Buronga Landfill Expansion

Amendment Report

Wentworth Shire Council

SSD-10096818
8 February 2023
Ref: 202597R07

Figure 2 Schematic Representation of Waste Sources and Destinations

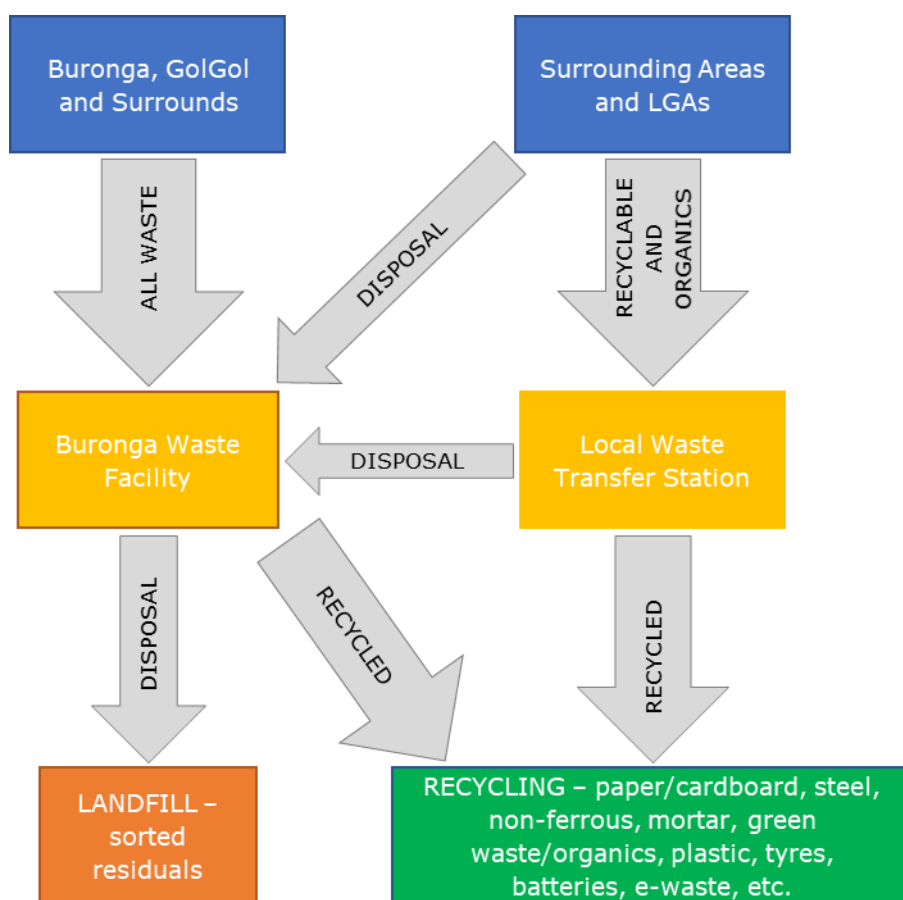
- *Updated Far West Regional Plan 2036 numbering errors*
- *Request additional information on justifying the demand for regional scale facility and 100,000 tonnes/year limit*

The waste disposal estimates do not allow for increases in diversion rates and hence provide a conservative estimate of waste for disposal. For example, the recent introduction of the green waste and food organics bin in Mildura is likely to result in a significant reduction on the quantity of waste for disposal. Also, WSC records (presented in EIS Table 3.4) show that an additional 23,000 tonnes was received as construction and demolition waste and commercial and industrial waste and a further 6,300 tonnes was received at the existing community recycling centre in 2020/21. The additional waste includes mixed wastes streams from domestic sources, tyres, etc., a significant proportion of which may be diverted from landfill by improving facilities to allow sorting.

The combined total of the kerbside waste for disposal (64,000 tpa) which may be directed from other LGAs combined with the other wastes received at the Buronga Landfill results in a total waste projected to be received at the facility by 2050 of around 100,000 tonnes. The actual volume is likely to be less than this as the estimates have assumed that waste for disposal from other LGAs is all received at Buronga and that there is no reduction due to improved diversion. The 100,000 tonnes was assumed as a conservative estimate to indicate the maximum scale of operation for approval purposes.

Figure 4 Extent of Existing Landfill and Future Piggyback Liner

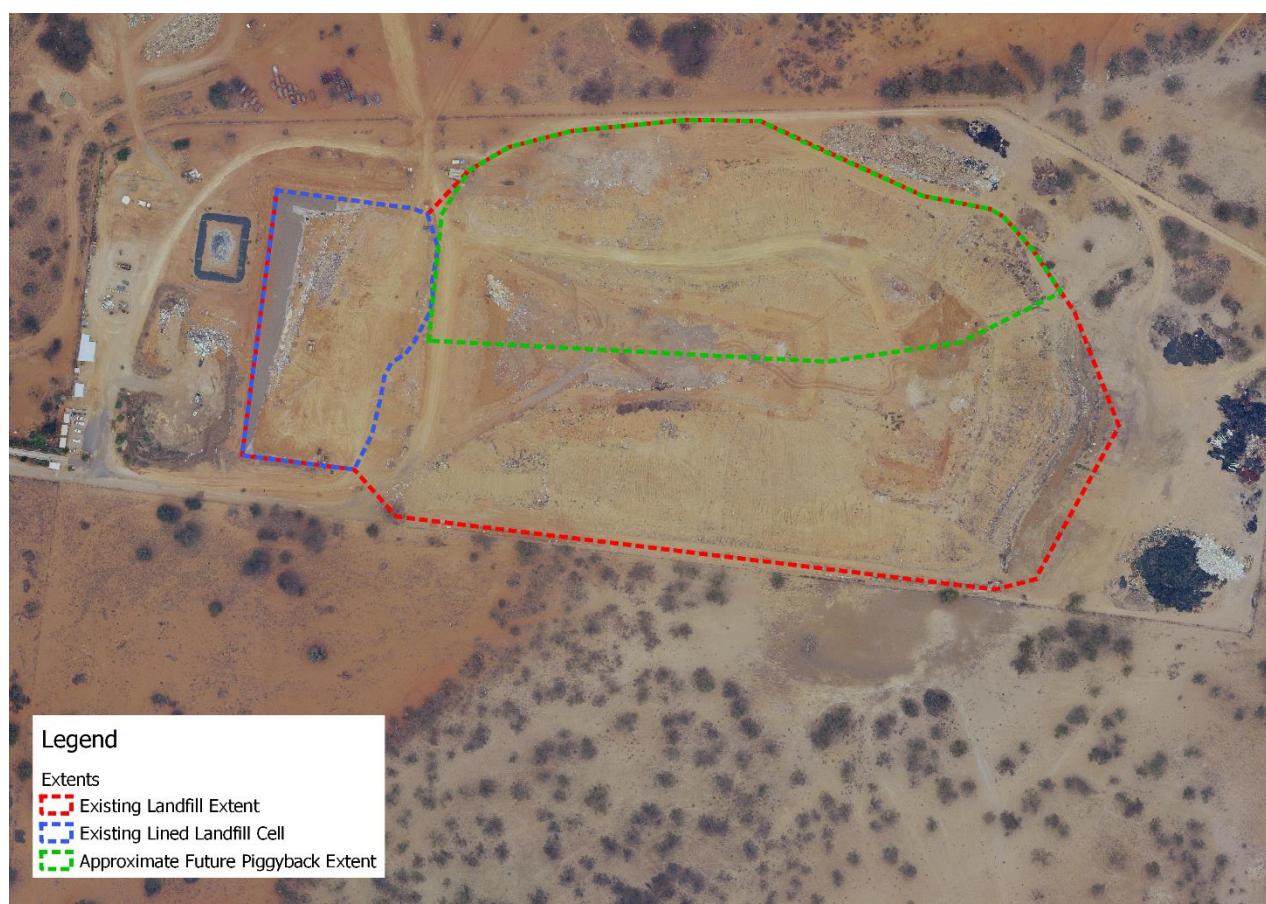
- *...,the likelihood of disturbing any existing contaminated land,...*

Areas of the historic unlined landfill that are not yet at or near the proposed final landform levels and require additional filling will be piggyback lined in accordance with the requirements of the *Environmental Guidelines: Solid waste landfills* and as agreed with the EPA. Figure 4 shows the approximate extent of historic unlined landfill that will require piggyback lining.

The design of the piggyback liner will be developed to minimise the disturbance required and to minimise any uncovering and exhumation of existing waste. Disturbance of the existing surface shall be addressed in the construction contractor’s construction environmental management plan (CEMP) to address potential risks associated with disturbance of potentially contaminated material including surface water and landfill gas controls if these are determined to be required. Safety associated with disturbance of potentially contaminated material shall be addressed in the contractors WHS plan.

Any exhumation or exposure of existing landfilled waste will require approval from NSW EPA who are the regulator for the environment protection licence for the site. Any potential approval will require a formal plan to be prepared detailing the proposed exposure and/or exhumation of waste and the appropriate environmental and safety controls that will be put into place during this work occurring.

Figure 5 Catchment Plan

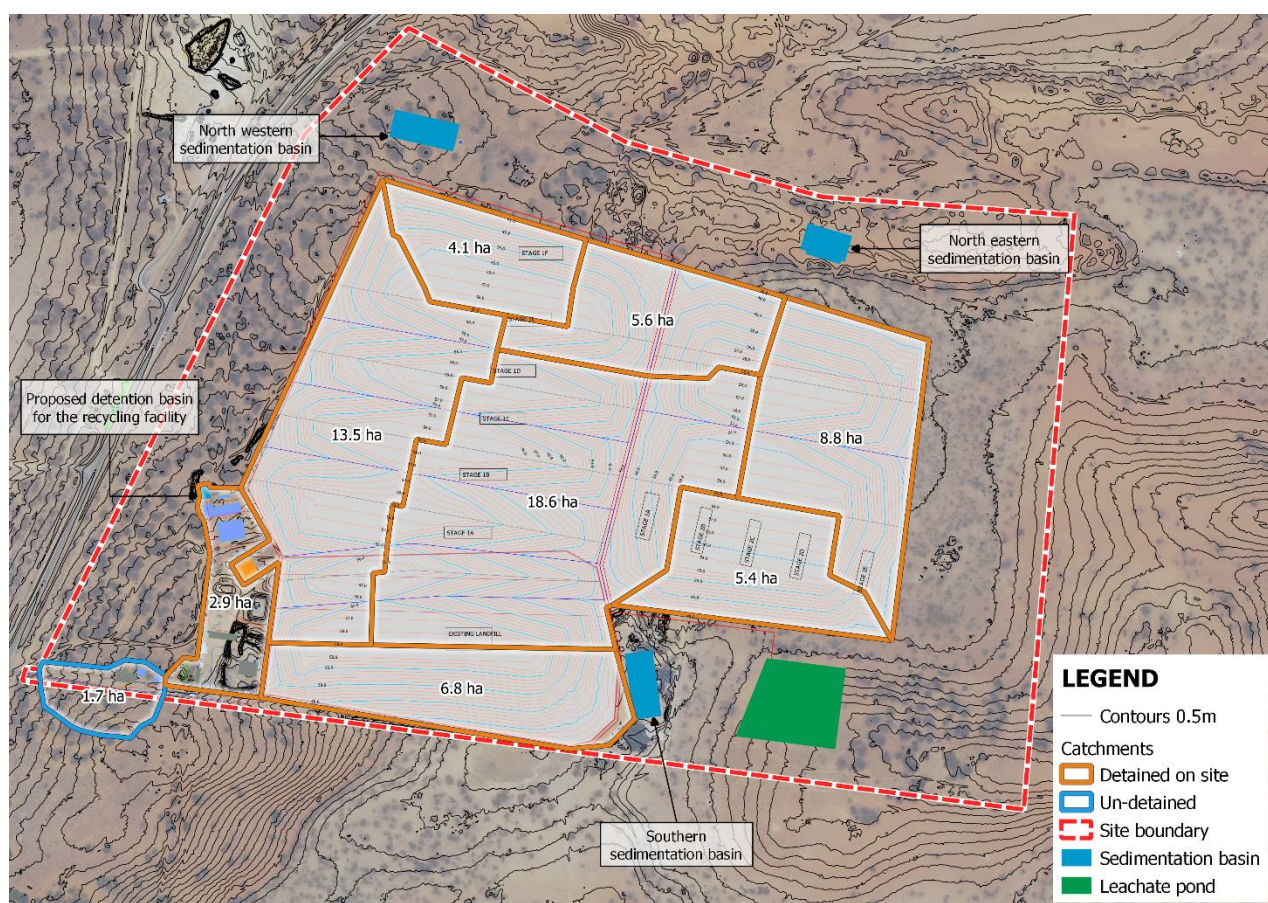
- *Details of the surface and stormwater management system and assessment of potential surface water impacts for the landfill and community recycling facility*
- *Amended drainage plan showing drainage lines consistent with the north-south orientation of Stage 2 landfill cells*
- *Details of how the new landfill cells in Stage 1 would connect to the existing leachate pond, which would be used until such time as the new leachate pond and service alignment are constructed*
- *Details of the capacity of the existing leachate pond, including approximate service life remaining and likely timing of the construction and use of the proposed new leachate pond and service connections*

The stormwater management plan has retained the full extent of the proposed landfill development (Stages 1 and 2). This will ensure if future landfill development is undertaken, there is adequate provision for and siting of infrastructure. All three stormwater ponds will be required for Stages 1A to 1D and will be located within the envelopes shown; however, the stormwater infrastructure will require detailed design to confirm sizing and is typically staged along with the landfill cell development and closure.

The governing methodology for the surface and stormwater management system is to detain potentially sediment laden runoff generated from the disturbed areas in a series of sediment basins. Runoff is to be discharged once a suitable level of water treatment is achieved. External catchments that are not subject to land disturbing activities have been identified. Runoff generated from these catchments is to be directed around the active recycling centre works area.

The topography of the site and surrounding landscape was reviewed to define the internal and external catchments. For the catchments within the site, the design contours for the landfill caps and existing site survey were used. To define the external catchments, DEM data (obtained from ELVIS) was used to generate contours of the surrounding area. Where external catchments are identified, bunds have been proposed to ensure runoff from these external catchments is directed away from disturbed areas of the site. As such, there are no external catchments draining to the stormwater treatment systems managing runoff from the disturbed areas of the site. The resulting catchment plan is shown in Figure 5.

Bunds are proposed along external alignment of the haul roads. These bunds direct external catchments (clean water) around the disturbed areas and into existing natural depressions in the surrounding landscape. Details of the bunds will be finalised in detailed design.

The catchment plan shows all but one of the catchments will have runoff detained on site. That one small catchment around the FERF will directly discharge runoff to Arumpo Road. The concrete hardstand of the FERF will be designed to grade toward a central location to prevent flows outside the footprint. Collected water will evaporate or be conveyed to the leachate pond. Roof runoff from all sheds will be collected in rain water tanks to allow reuse. Runoff from all other catchments will be conveyed via grass

Figure 6 Drainage Plan

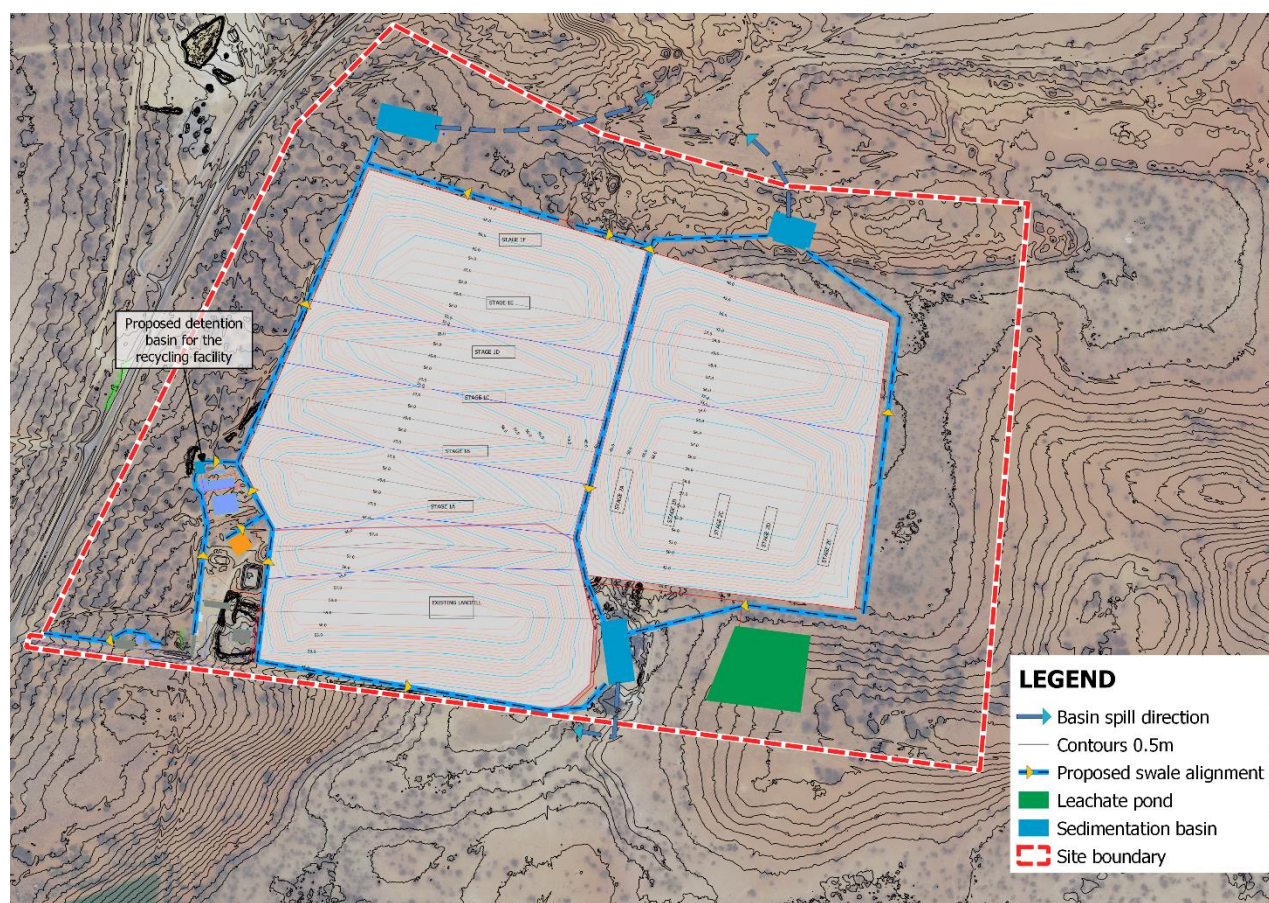
- *Amended drainage plan showing drainage lines consistent with the north-south orientation of Stage 2 landfill cells*

Preliminary sizing of the grass-lined swales has been conducted using DRAINS. The model was run using the sub-catchments as shown in Figure 5 for the 20-year ARI (5% AEP) rainfall event. Based on the modelling results, a typical swale sizing is obtained and described below:

- Batters – 1V:5H
- Depth – 0.5 m
- Base width – 1 m

It should be noted that the sizing of the grass-lined swales as well as the swale surface treatment is to be finalised during detailed design. The concept drainage plan showing the proposed alignment of the grass-lined swales is provided in Figure 6.

Figure 6 also shows the proposed sedimentation basin spill directions. The spill directions have been determined to allow the overflows from the basin to spill towards the natural watercourses and depressions in the surrounding landscape. Spillway design for the basins will be finalised in detailed design.

The drainage plan is for stormwater drainage and hence needs to be consistent with the final landform and not the cell orientation. Whilst the cells are being filled, any rain falling within the cell will be in contact with waste and hence is considered leachate and directed to the leachate ponds from the cell sump and via pipework to the leachate evaporation ponds. The stormwater design is for the interim and final landforms where the waste is covered by soil and any runoff is not in contact with the waste so remains "clean".

Figure 10 Native Title Applications and Determinations (National Native Title Tribunal)

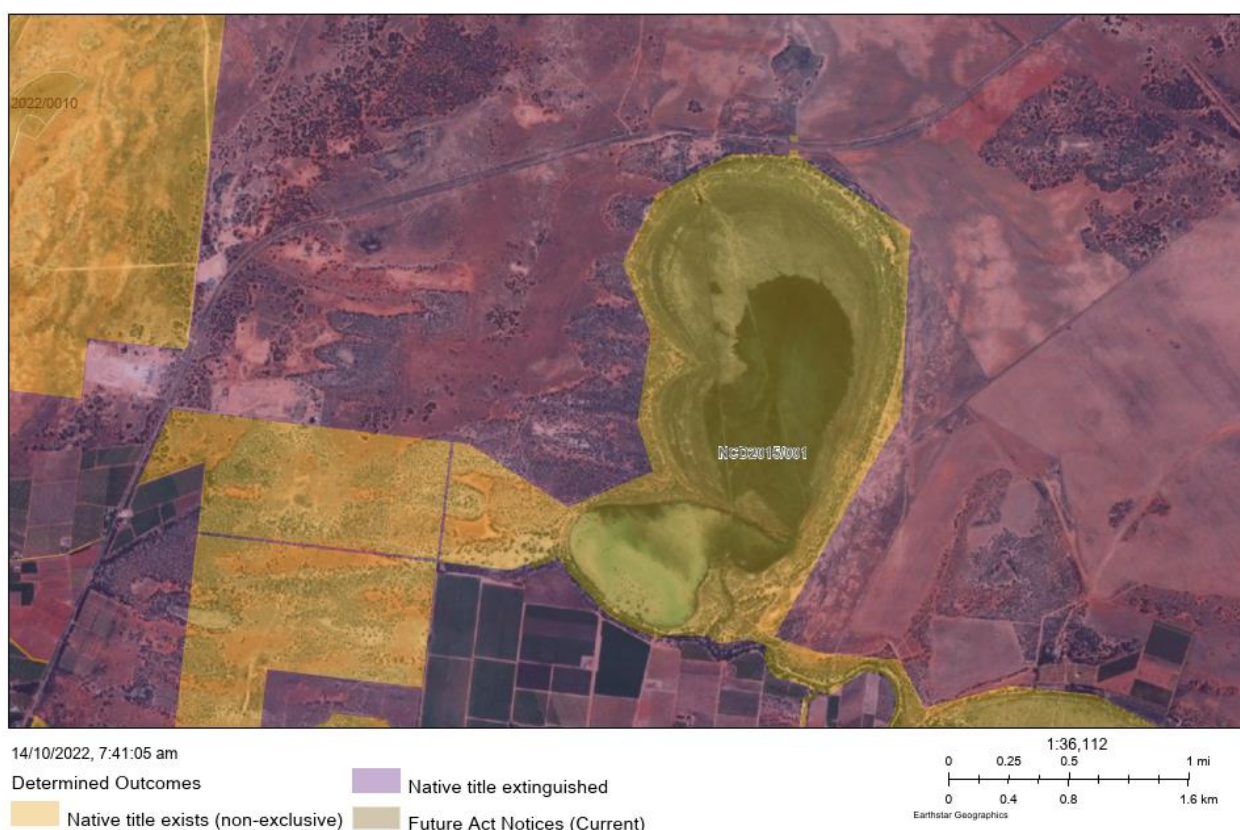
- Confirmation that two Crown road lots adjoining the project footprint will not be impacted, or otherwise provide Crown consent or details of any proposed acquisition of Crown land

The aboriginal land claim has still not been determined and, as noted by Crown Lands, is still considered likely to be refused. A Request for Search of a Land Claim has been submitted to the Office of the Registrar but no response has been received to date (Appendix P). Previous discussion by Council Officers with staff from the Crown Land Aboriginal Land Claims Unit has indicated that Crown Lands intend to deny the claim as the parcels of land subject to the claims are being used for their gazetted purpose.

With respect to native title over the crown land and Council- owned land it is also noted that Schedule 5 – Description of Extinguished Areas as part of the above claim by the Barkandji Traditional Owners lists Lot 197 and 212 DP 756946 as extinguished. An extract from the National Native Title Tribunal is shown in Figure 10, extracted on 14/10/2022. The extinguishment of native title may reduce the potential for these lots to be subject to any native title claim.
